NOTICE OF PREPARATION (NOP), NOTICE OF COMPLETION (NOC), INITIAL STUDY, AND NOP COMMENT LETTERS

NOTICE OF PREPARATION

Subject: Notice of Preparation of an Environmental Impact Report (EIR) pursuant to the Requirements of the California Environmental Quality Act (CEQA) for the Portuguese Bend Landslide Mitigation Project

Project Title: Portuguese Bend Landslide Mitigation Project

Figure 1
Portuguese Bend Landslide Mitigation
Project Site Location

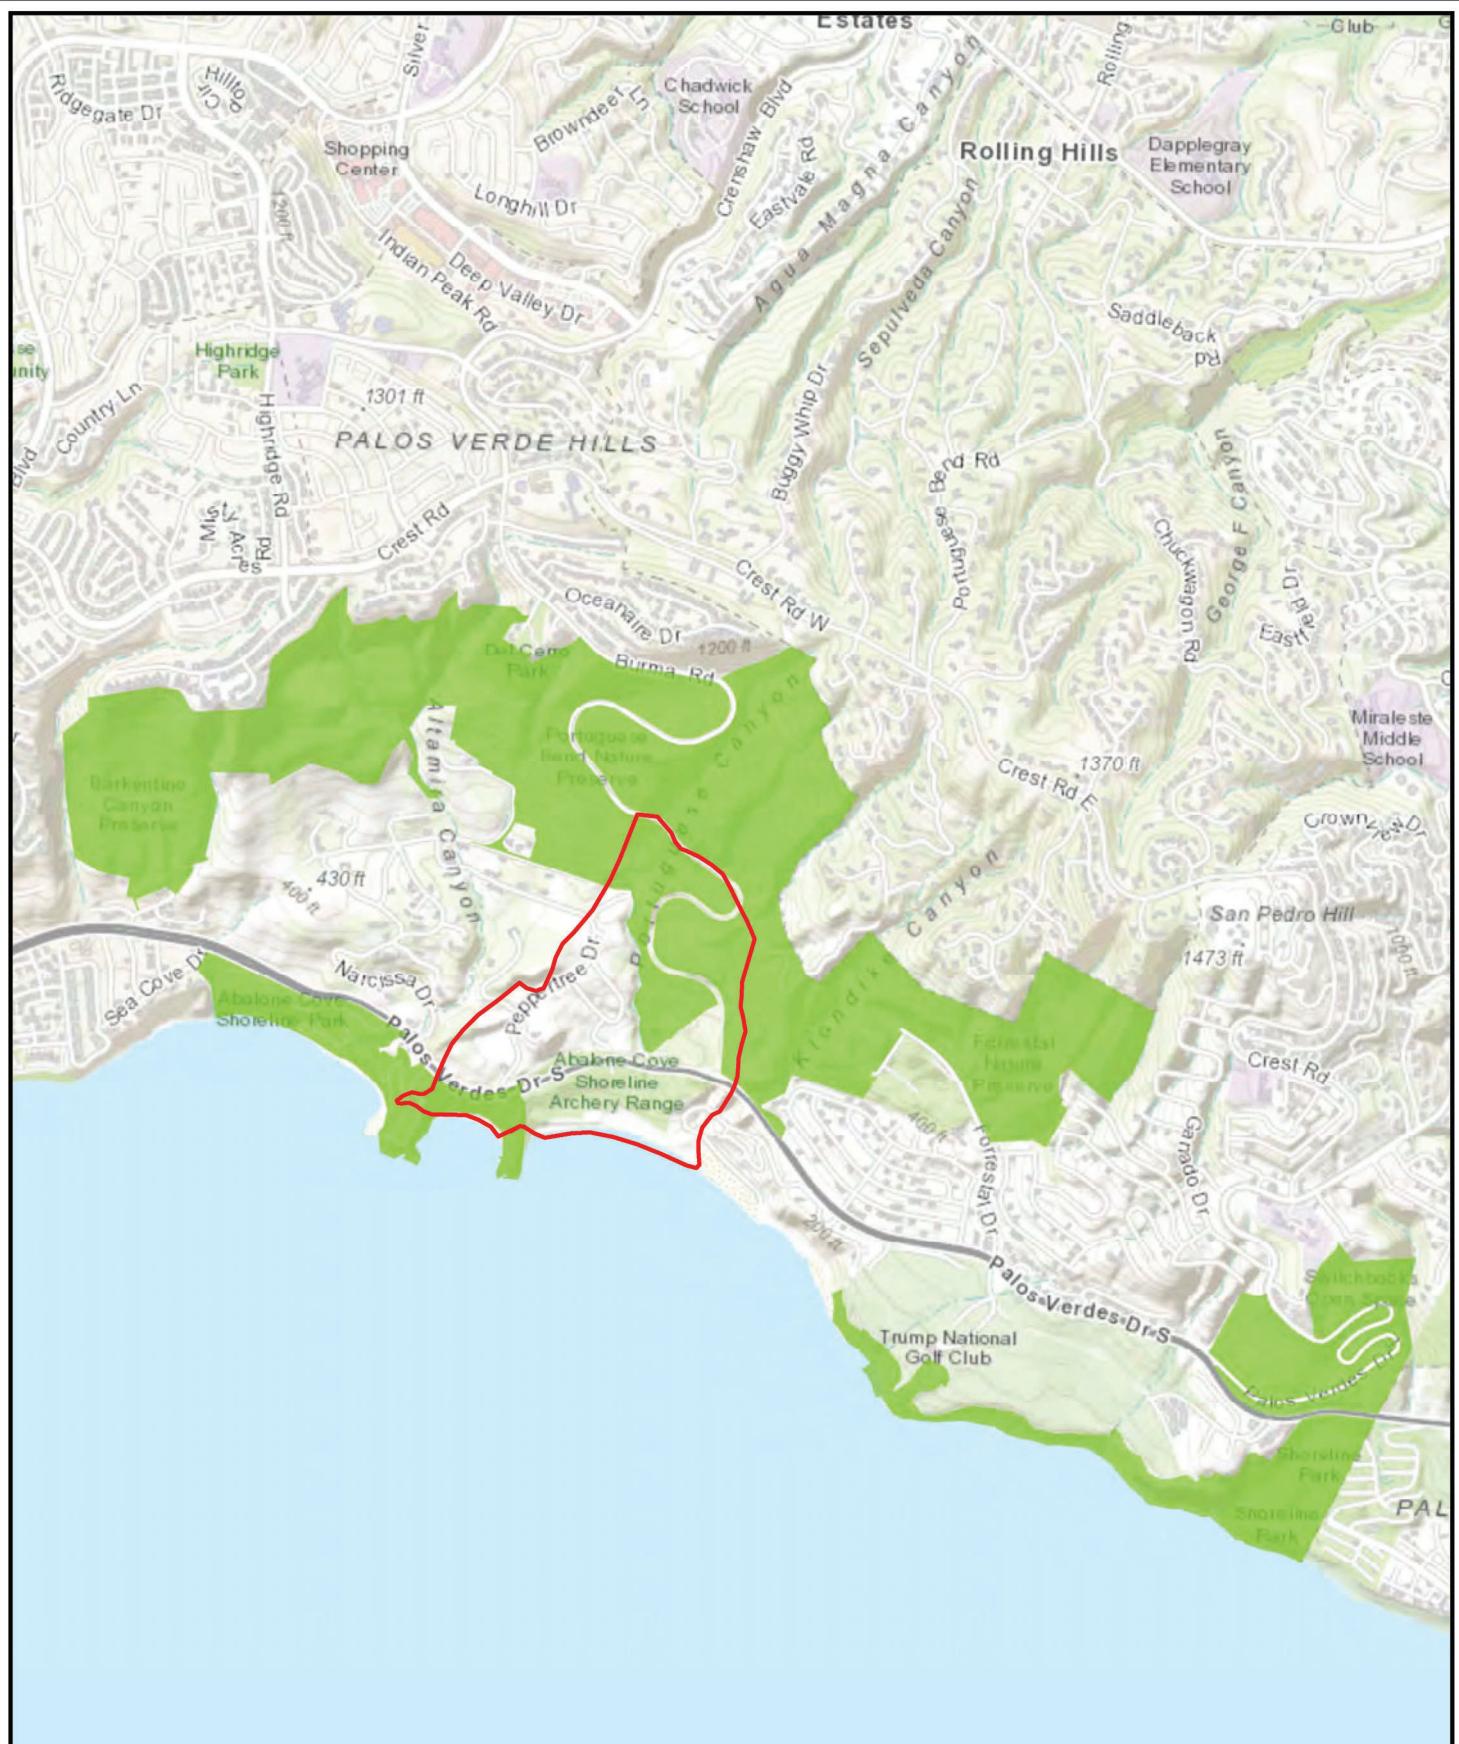
Figure 1 (as well as all other figures) shows a project area that excludes most of Abalone Cove Shoreline Park and is inconsistent with the project description.

1.1. Expand the project boundary to provide a margin of 180 feet along the easterly (up-slope) side of Burma Road Trail. (Portuguese Bend Mitigation Project, Nov. 2020, Chambers Group, Section 1.2, p. 5 and Figure 1, Project Site Location)

Figure 2
Portuguese Bend Landslide Mitigation
Palos Verdes Peninsula Conservancy Areas

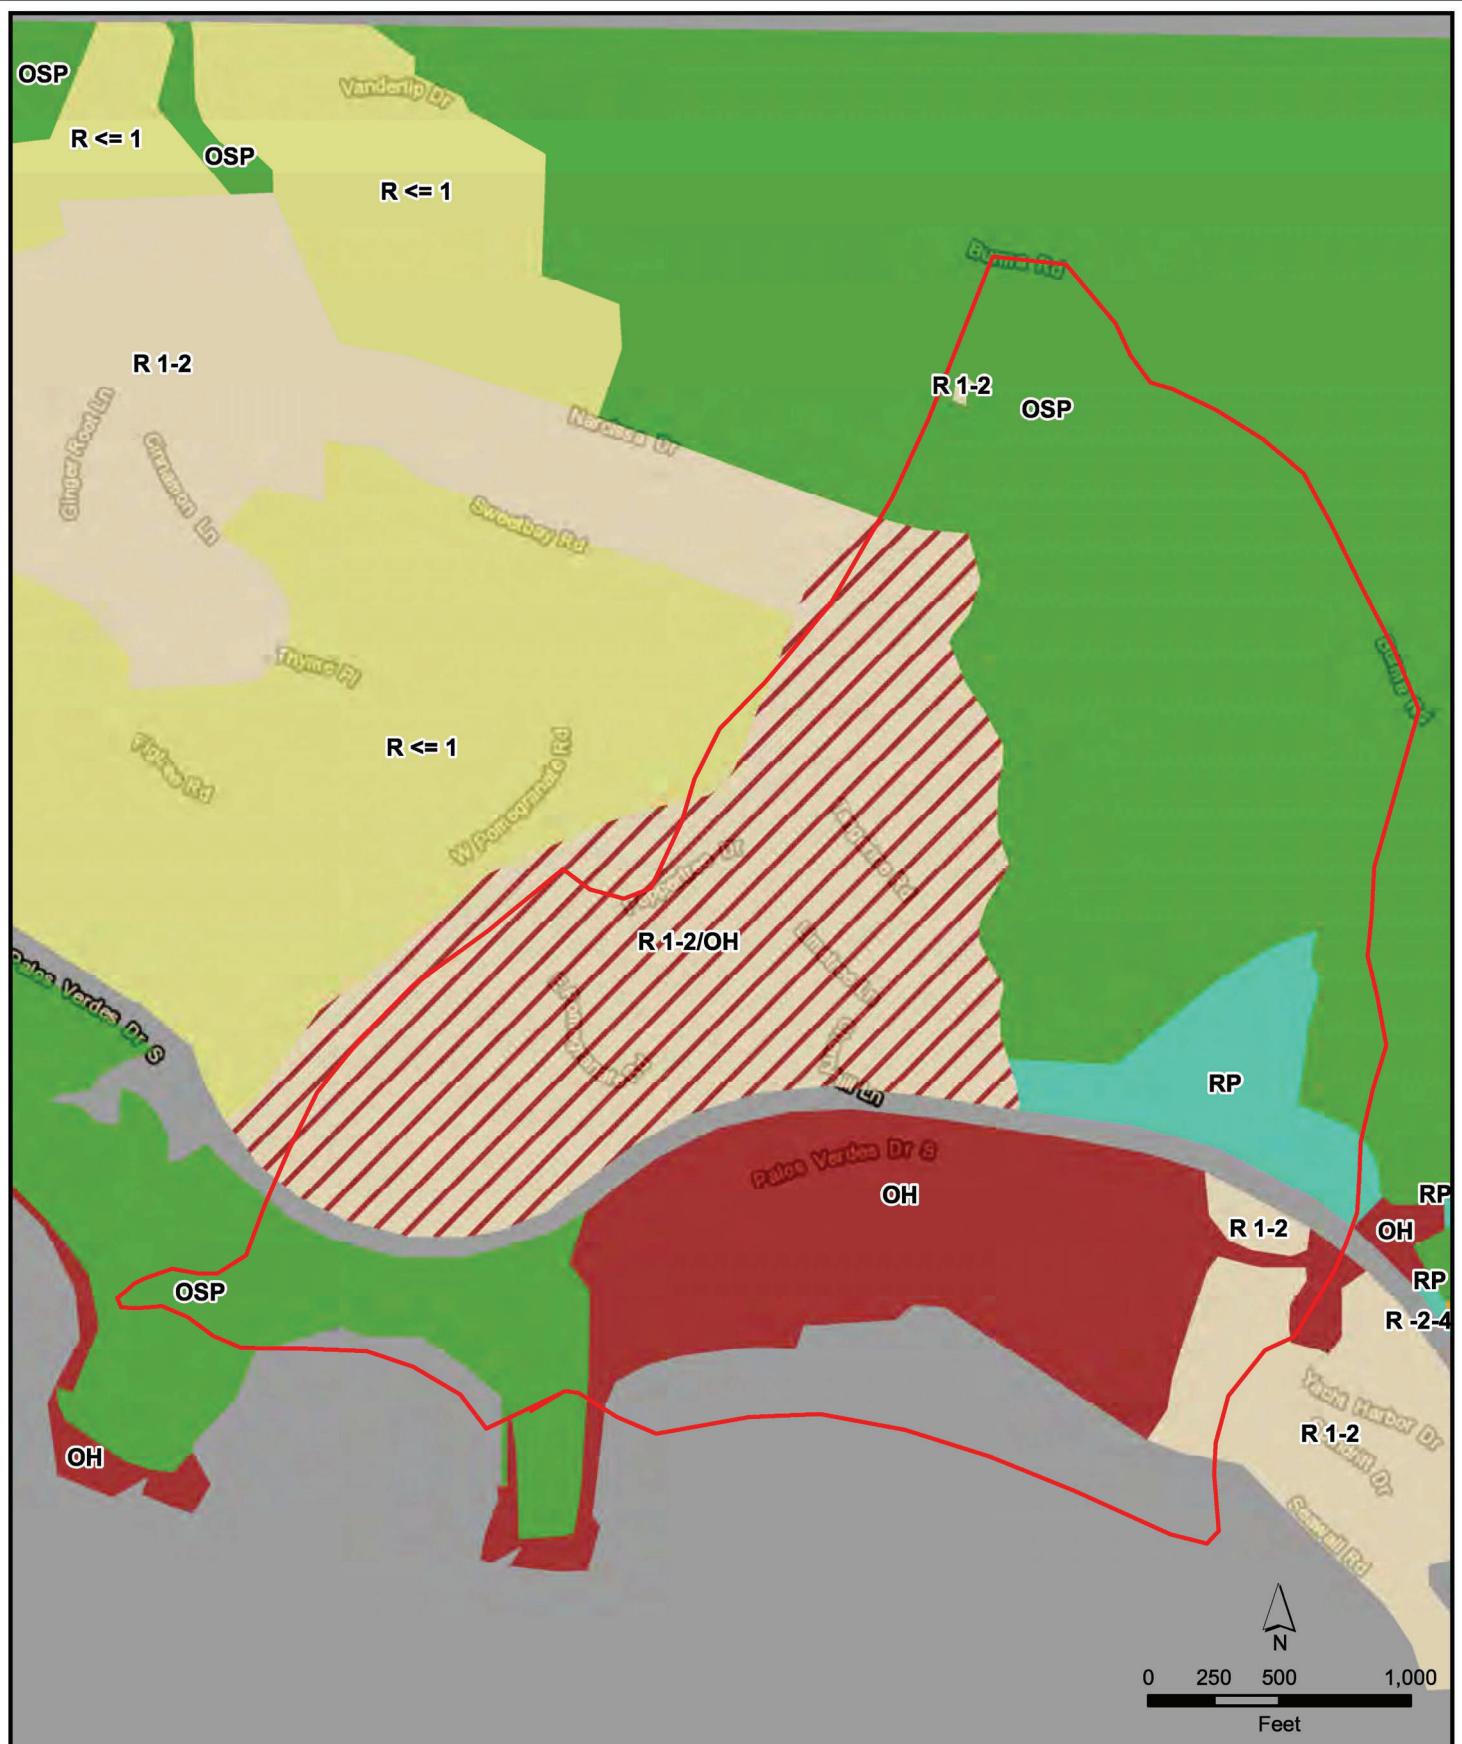
The Initial Study (IS) seems to underplay the importance of the NCCP. The map in Figure 2 shows "Palos Verdes Conservancy Areas" rather than identifying the area shown as land covered under the NCCP.
